SECY-97-229

SUBJECT: GRADED QUALITY ASSURANCE/PROBABILISTIC RISK ASSESSMENT  
IMPLEMENTATION PLAN FOR THE SOUTH TEXAS PROJECT ELECTRIC  
GENERATING STATION

This commission paper transmits the NRC staff's safety evaluation report (SER) regarding a proposed revision to the Operations Quality Assurance Program (OQAP) description applicable to the South Texas Project (STP) Electric Generating Station, Units 1 and 2. The proposal by the Houston Lighting and Power Company (the licensee), submitted on a voluntary basis, derives from the application of graded QA (GQA) controls, as permitted by NRC regulations (Title 10, Part 50, of the Code of Federal Regulations (10 CFR Part 50), Appendix A, General Design Criterion 1, and Appendix B, Criterion II), and is based on a risk-informed approach including Probabilistic Risk Analysis and traditional engineering evaluations. On the basis of the findings documented in the attached SER, the Office of Nuclear Reactor Regulation (NRR) intends to approve the licensee's proposed revision to the OQAP description for implementation at STP.

## **Figure 1**

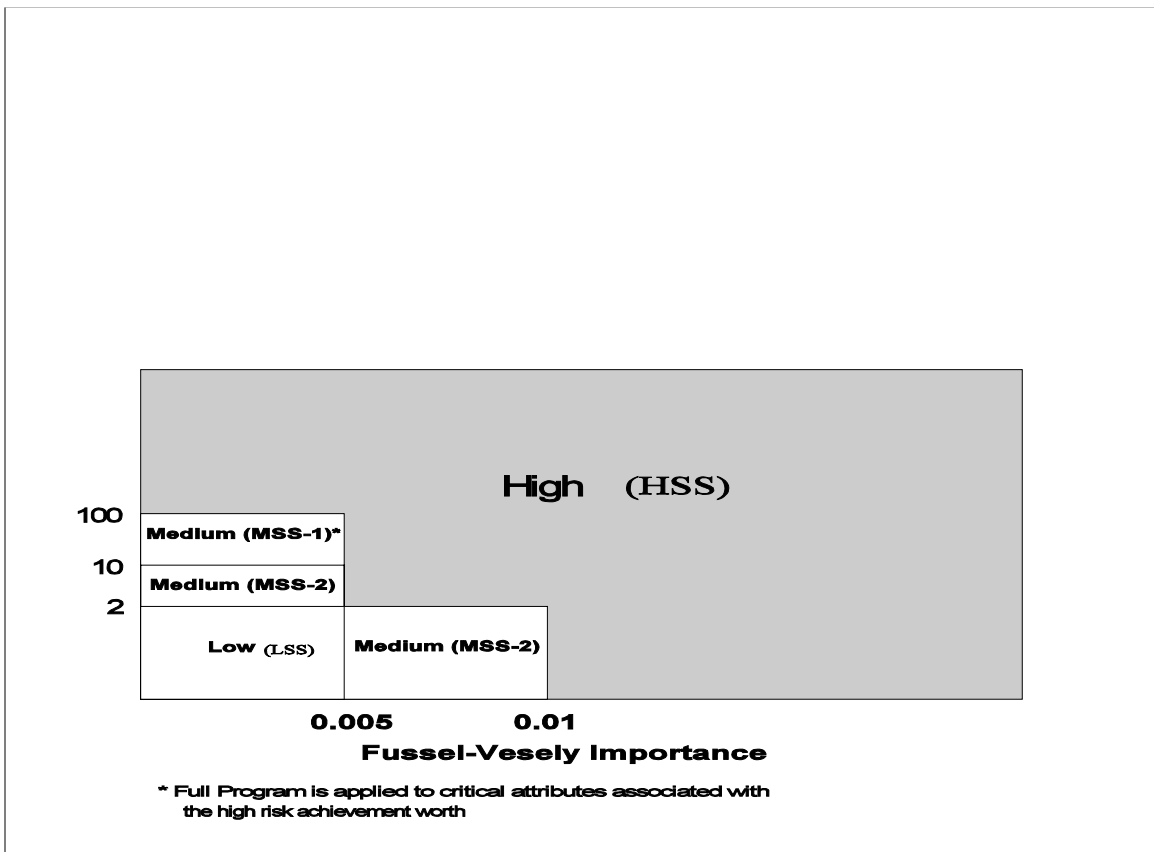
Figure 1 graphically illustrates the relationship between the RAW, FV, and the safety-significance categories for those SSCs modeled in the PRA. Since FV and RAW are relative measures, both CDF- and LERF-related results are compared to the guidelines and the SSC assigned the highest category. The staff finds this process acceptable, and that the suggested RAW and FV values provide reasonable assurance that plant equipment will receive a level of QA control commensurate with importance to safety. Furthermore, since the licensee assigns all SSCs with elevated RAW to the HSS or MSS-1 categories, the staff finds that the licensee's proposal conforms with the Draft RG DG-1064 (Reference 3) position that high reliability alone is not sufficient for reducing QA controls.

To investigate the contribution of plant safety attributable to the successful operation of the LSS SSCs, the licensee performed sensitivity studies in which the unavailability was simultaneously increased for all modeled SSCs which could be eventually subjected to reduced QA controls. The calculations for these studies were performed using the PRA logic model (rather than cut-set or sequence results), so truncation errors did not require special study. The staff finds the sensitivity studies to be an acceptable method of ensuring the potential aggregate risk impact of the reduction of QA controls on the LSS SSCs is well understood.
